D/R OVERLAY DISTRICT PERMIT APPLICATION

Ivory on 23rd

PLANNING COMMISSION STAFF REPORT

DROD-03-22

7 UNIT BUILDING - ELEVATIONS

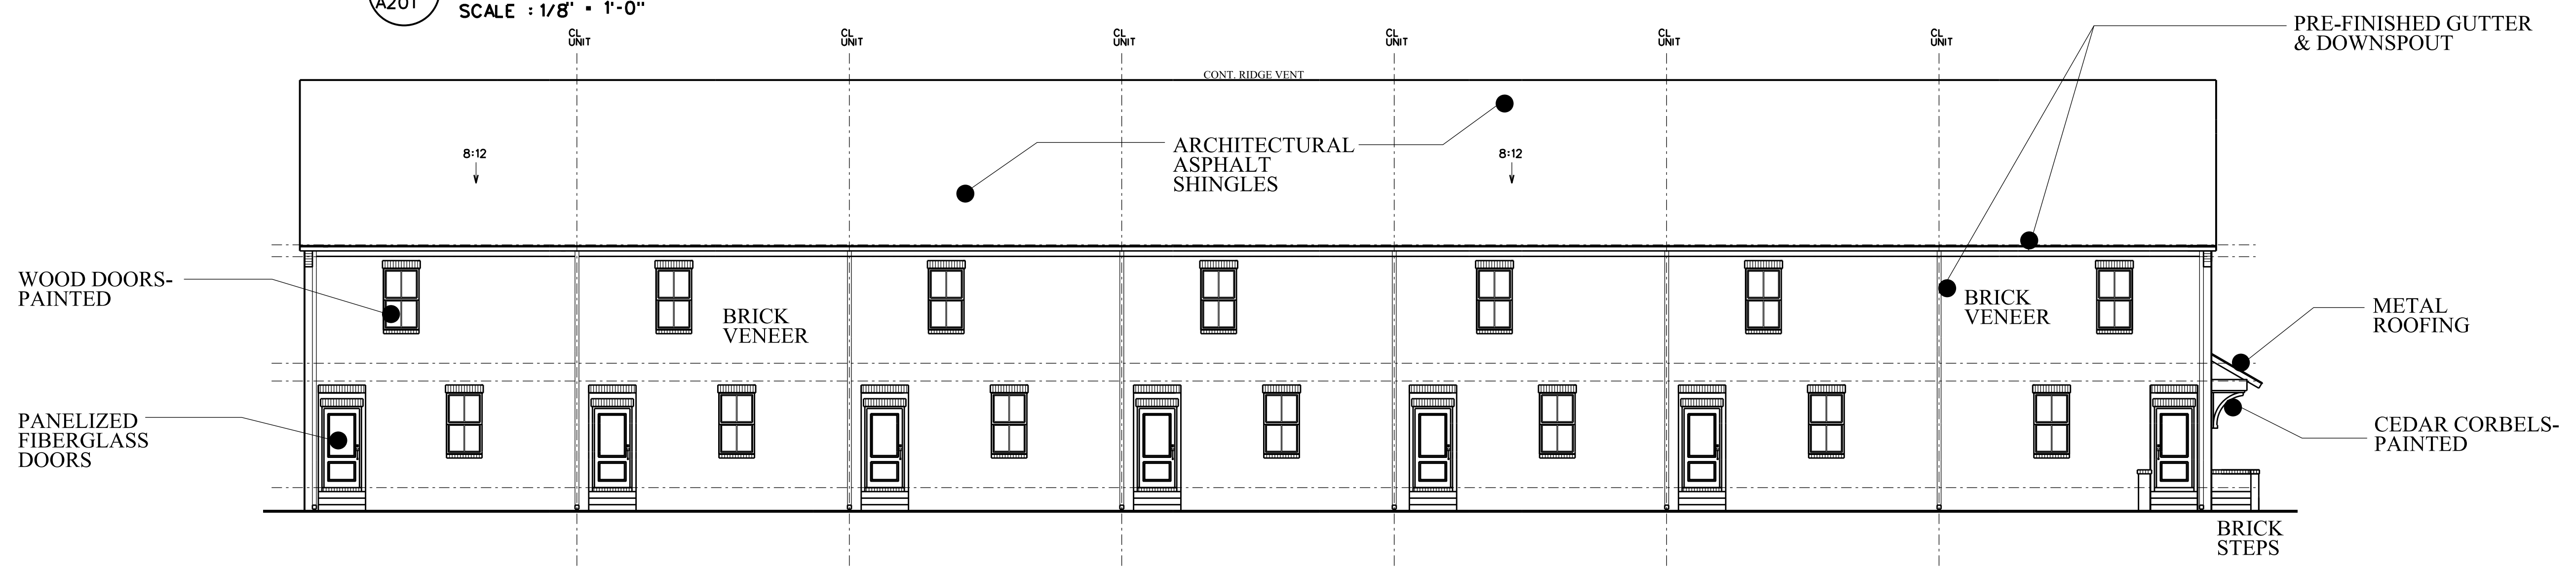
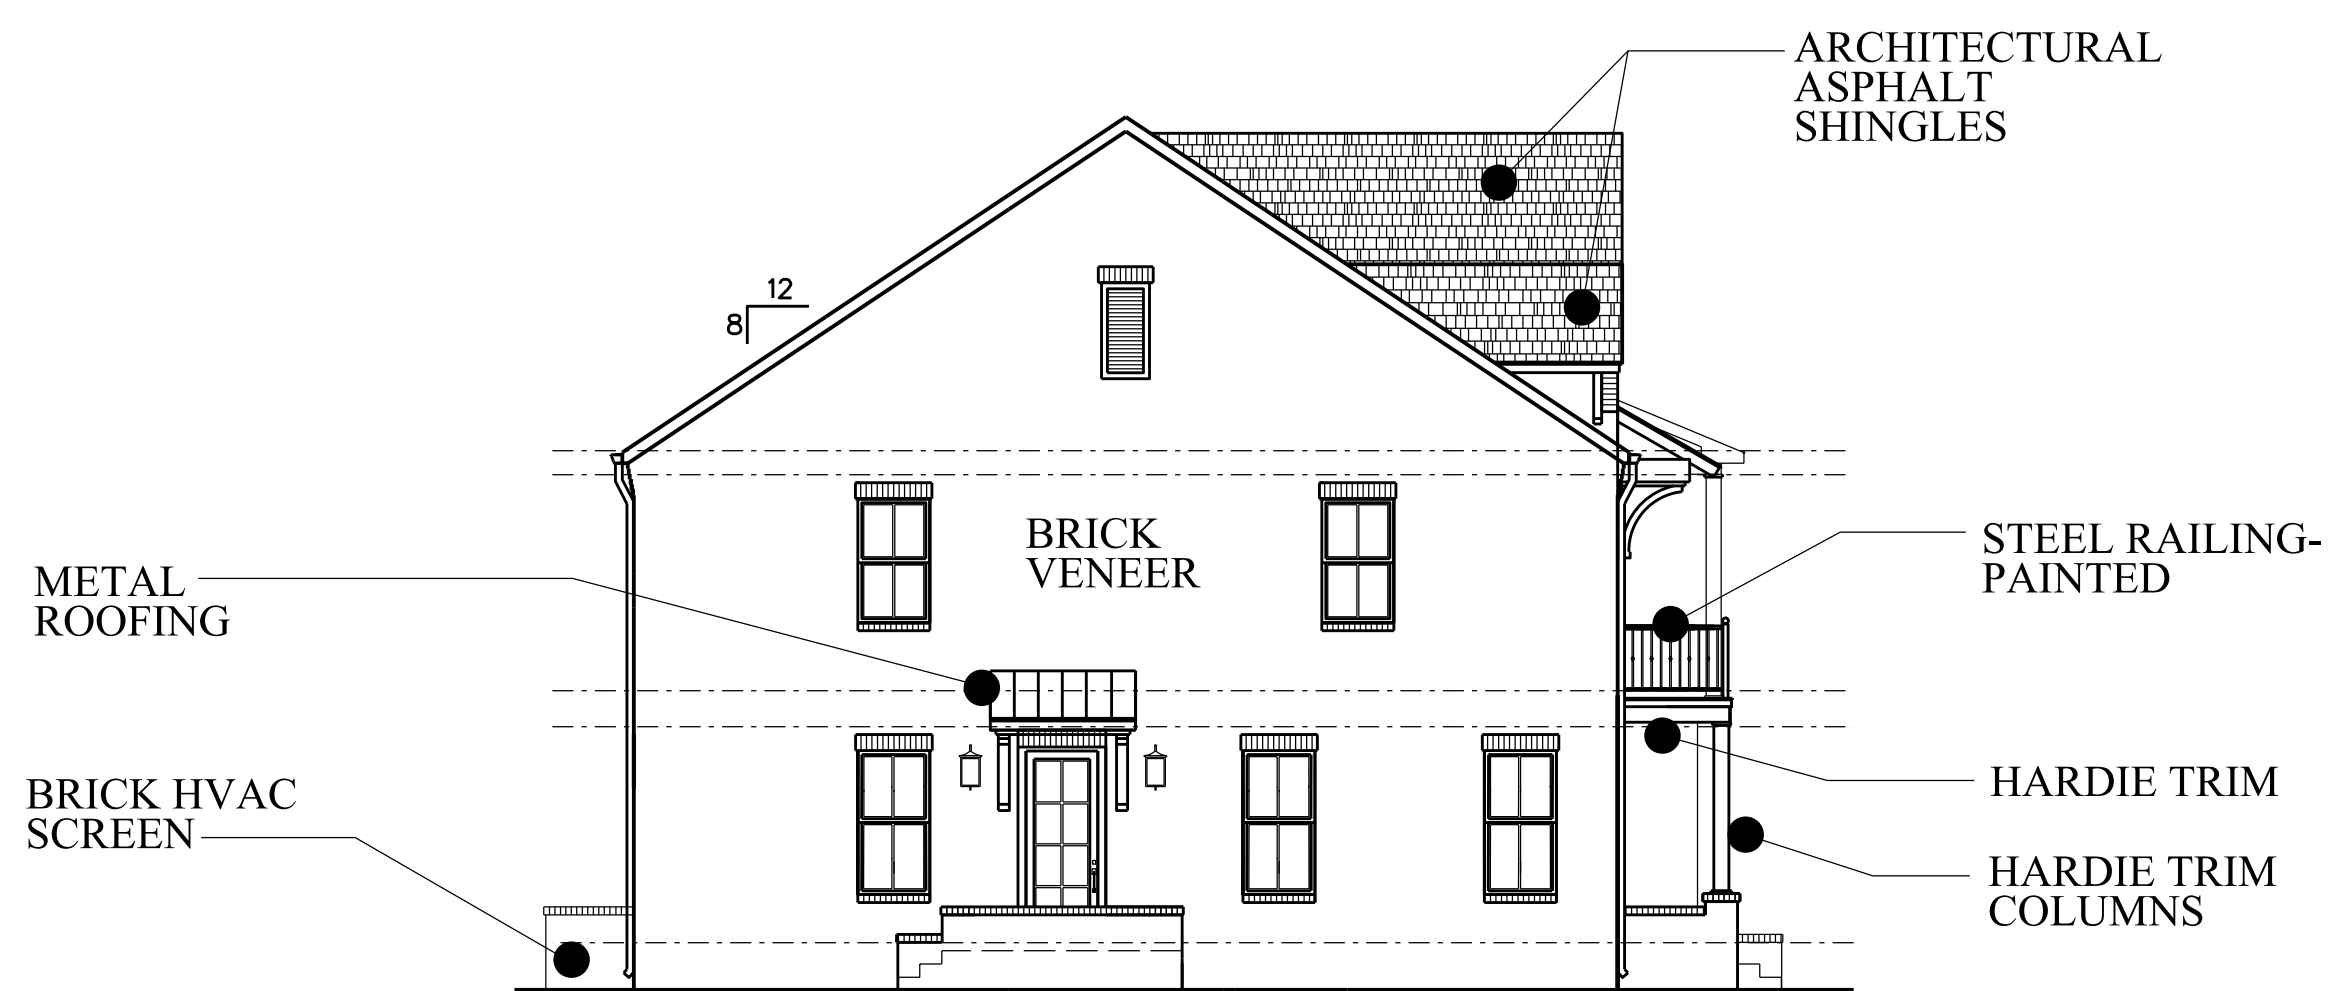
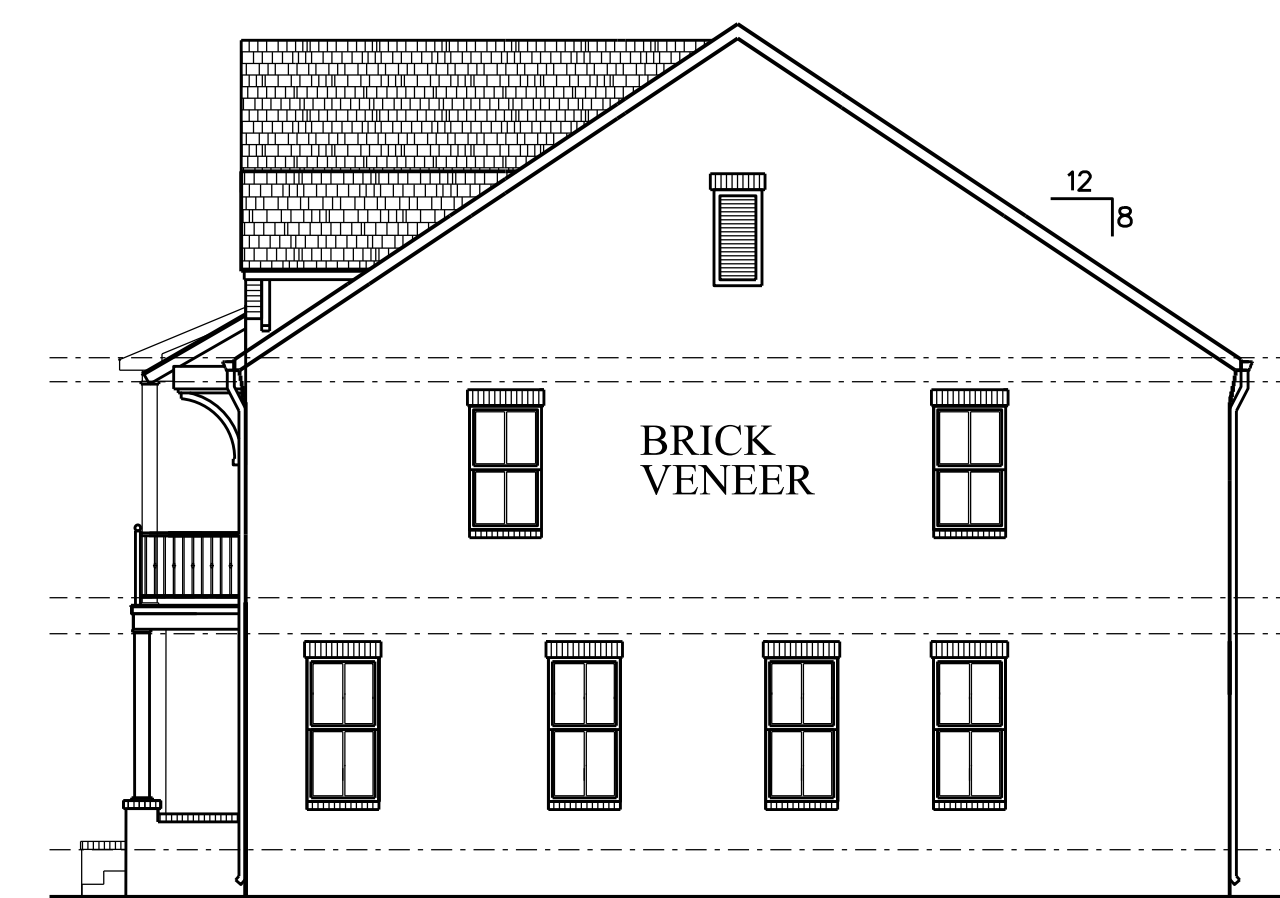
The architecture, scale, and site design of this proposal is consistent with several other townhouse developments in the Downtown Riverfront Overlay District. The Architectural Review Committee commented that the seven-units building does not meet guideline “O. Avoid use of blank walls at the street level.” Along 15th Street. These comments have been forwarded to the applicant and the Planning Commission members. Overall, the development proposal meets the intent of the Downtown Riverfront Overlay standards and guidelines in accordance with [Section 24-230\(b\)](#).
